Re: Buncombe County Substantial Amendment and Phase 5 PTC Application
 Response to Comments – Landfill Gas Monitoring Plan

Subject: Site Hydrogeologic Report, Design Hydrogeologic Report, Water Quality
Monitoring Plan, and Landfill Gas Monitoring Plan
Buncombe County Solid Waste Management Facility
Permit to Construct Application
Substantial Amendment and Phase 5
C&D Landfill
Response to Review Comments
Permit No. 11-07

This letter contains responses and revisions as they apply to the Landfill Gas Monitoring Plan. The comments are addressed individually with discussions and references within this letter and the attachments. Solid Waste Section comments are provided in italics with CDM response directly following. A complete revised Landfill Gas Monitoring Plan is attached.

PROJECT NO. 6447-65973
 FILE NAME: METHANE FIG. 1.dwg
 FIGURE
 3-1

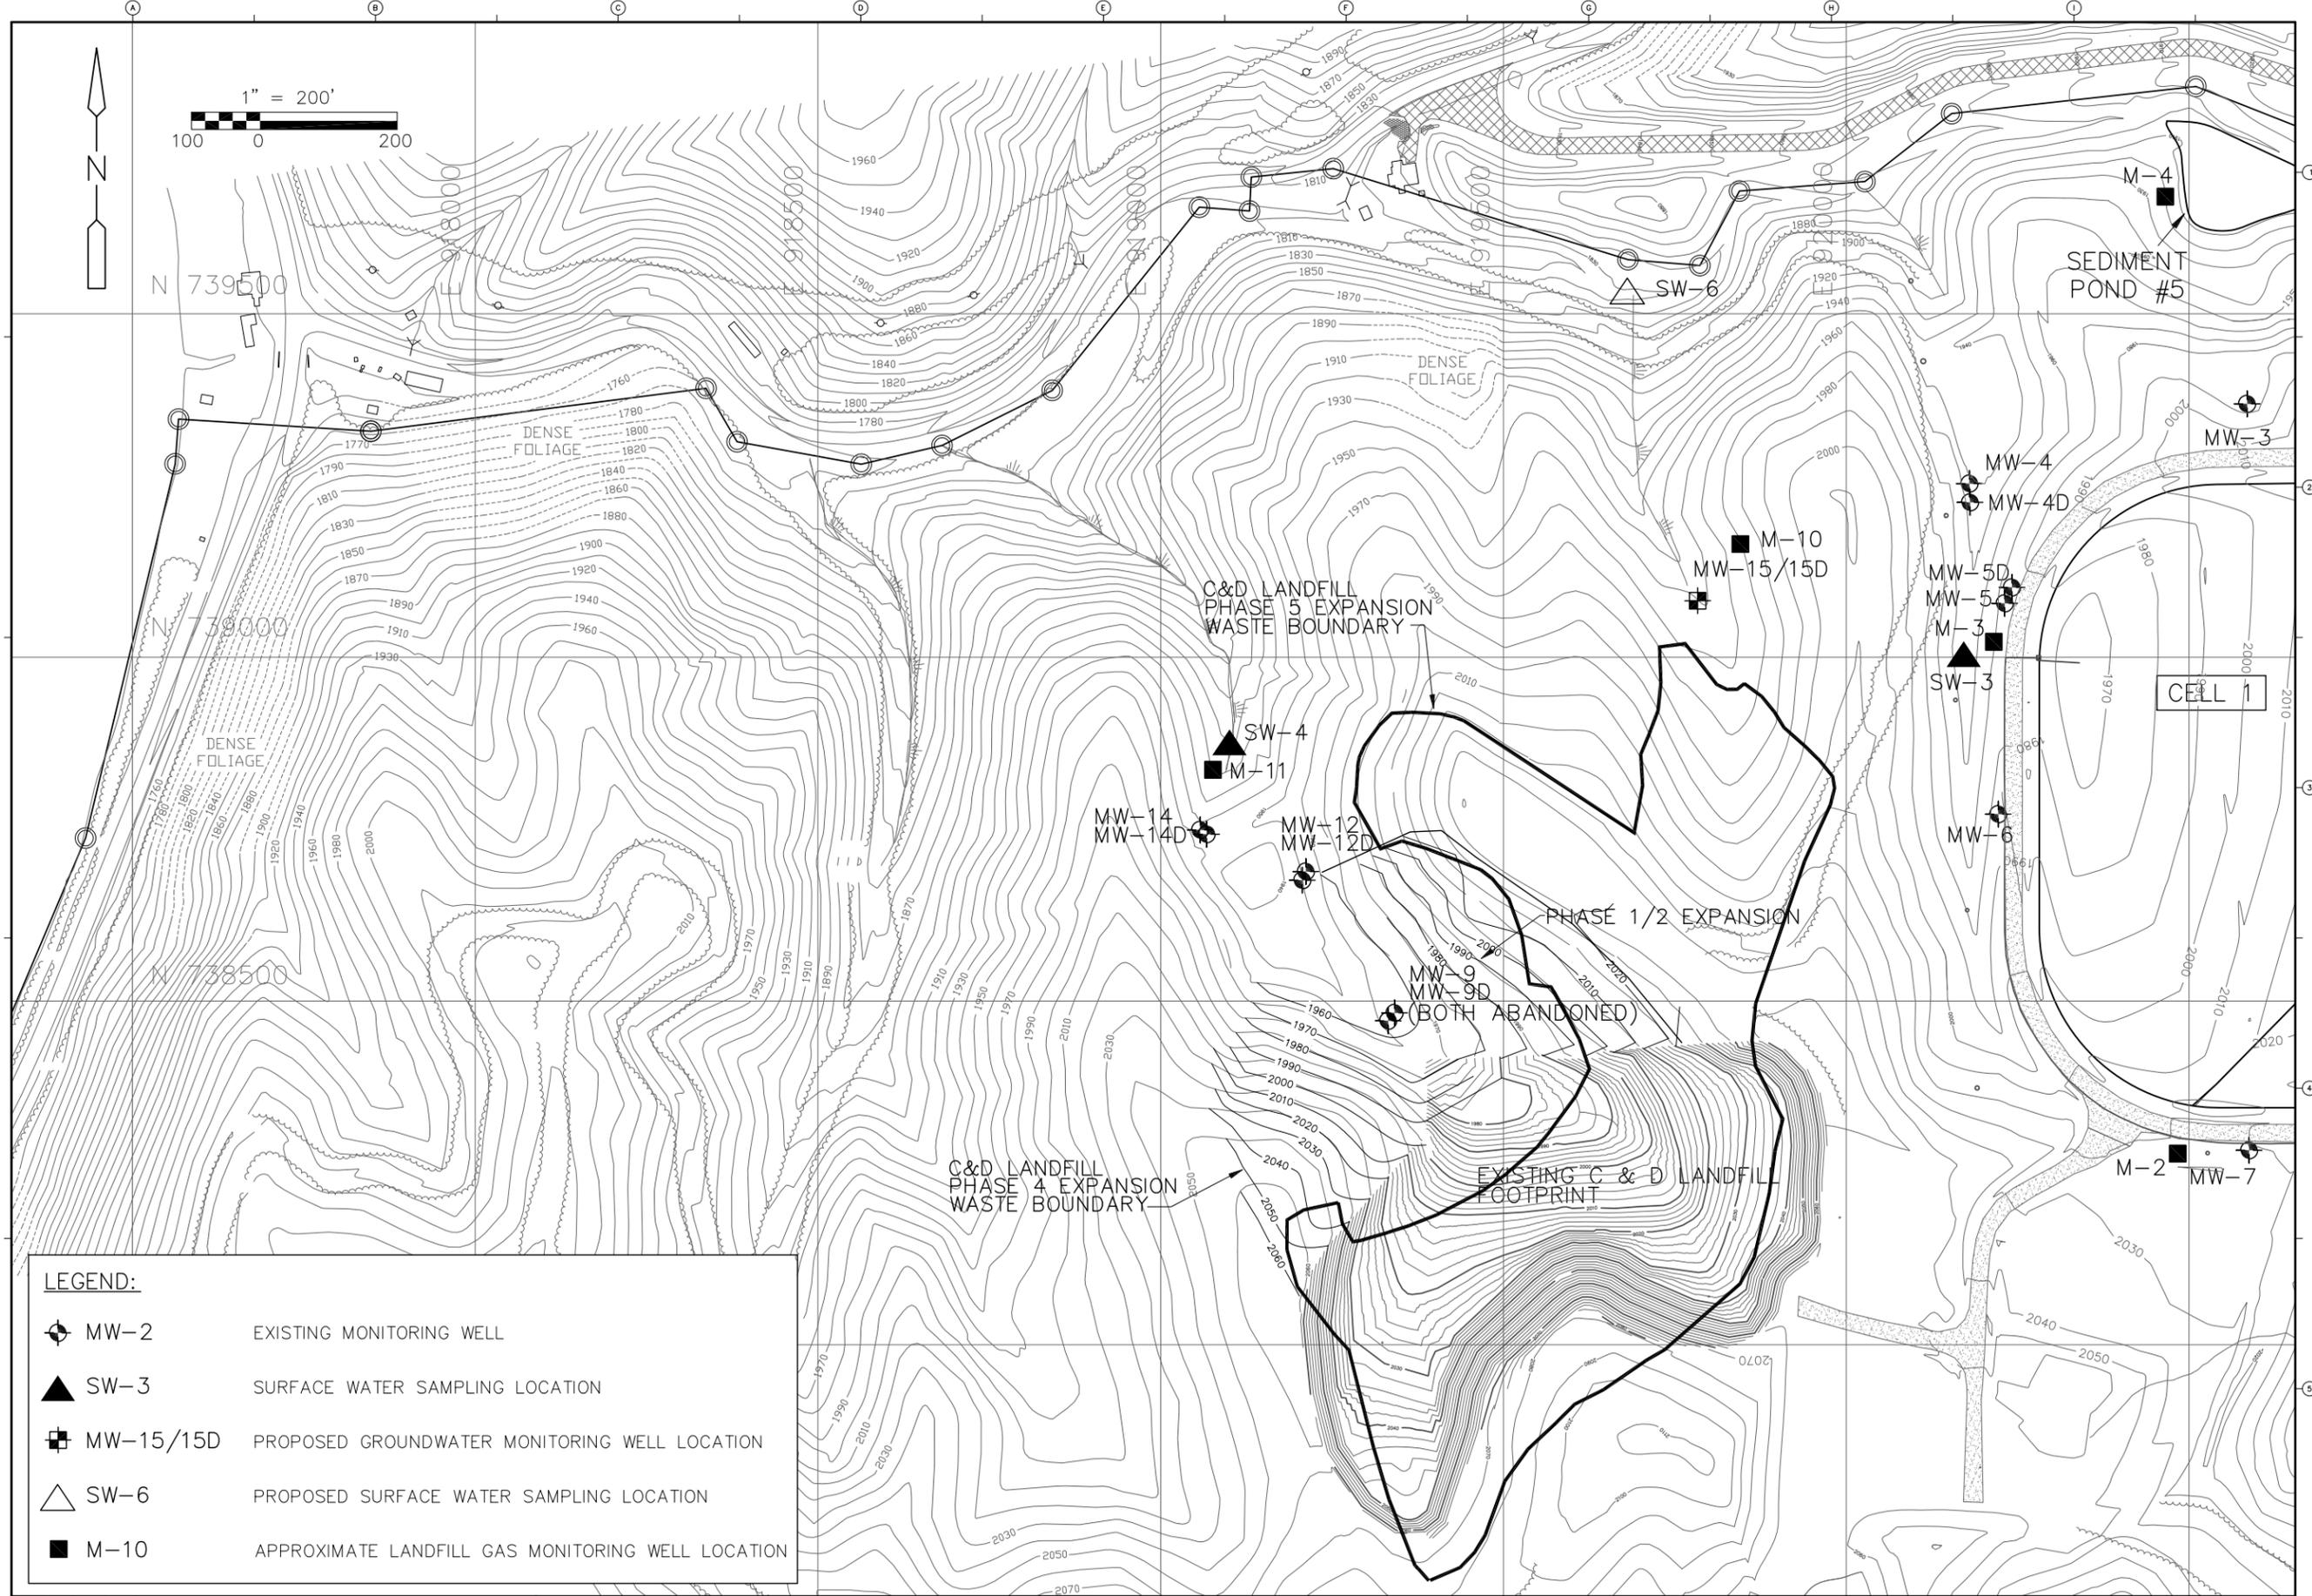
Sheet 1 - Show more monitoring. Space landfill gas monitoring wells no further than 500 feet apart along a perimeter around the waste boundary. Because the landfill contains no excavation beside which wells can be installed, show wells on the nearest high elevations-ridges, knolls, etc-adjacent to waste placed in valleys and low terrain. Show at least one well among the structures next to the landfill. Show wells placed on the review boundary already depicted and utilized on the drawing. If you have any questions, please contact me.

RESPONSE: CDM has installed monitoring wells M-10 and M-11. Well locations are provided on the revised Figure 3-1. Current well spacing is approximately 650 feet. Well locations were selected based on the topography and the fact that the drainage features act as preferential

pathways for both groundwater and gas. Arbitrary well placement at 500-foot intervals is not practical for this site. Additional wells are not necessary to the east of the C&D unit, as there are currently wells between the C&D and the Subtitle D landfill that are monitored under the approved Subtitle D plan. Adjacent wells are shown on Figure 3-1.

Placement of a monitoring well adjacent to a structure is not an appropriate way to monitor structures. As stated previously, the structures are currently monitored under the approved Plan for the Subtitle D landfill. As such, quarterly monitoring is conducted within the structures themselves. No additional monitoring locations are necessary.

The review and compliance boundaries shown on Figure 3-1 are in reference to groundwater and have been removed. According to Rule .0544(d)(1)(B), the owner or operator of the landfill must ensure that the concentration of methane or other explosive gases does not exceed the lower explosive limit for methane or other explosive gases at the facility property boundary. The existing wells at the C&D landfill are approximately 125-feet from the landfill. The location of these wells will facilitate early detection of landfill gas migration, if present, before it reaches the facility property boundary.

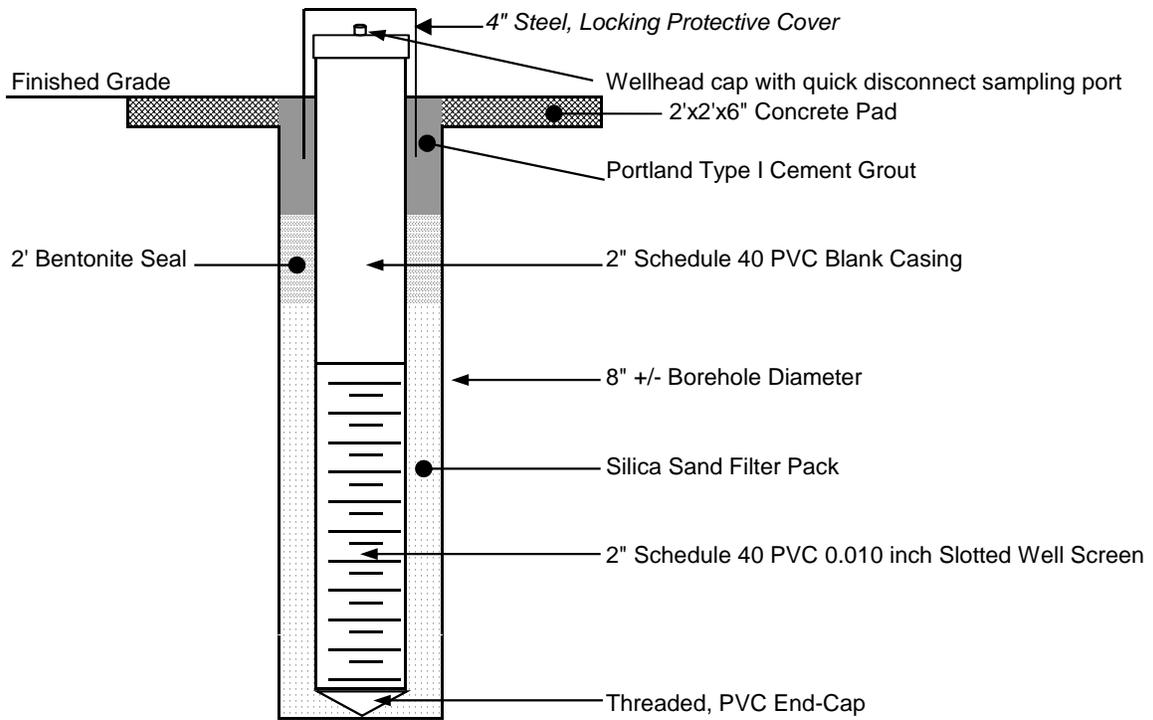
Figure 1 - Revise the detail to convey applicable criteria listed in comment for Section 3.2.1.

3.3.1f Wellheads will be fitted with a quick-connect stop-cock-type fitting that is of sufficient quality to facilitate sampling in accordance with industry and federal standards. Figure 3-2 has been revised to show the wellhead completion.

RESPONSE: Figure 3-2 has been revised to show a well cap with a quick disconnect sampling port, as described in the revised Section 3.3.1.
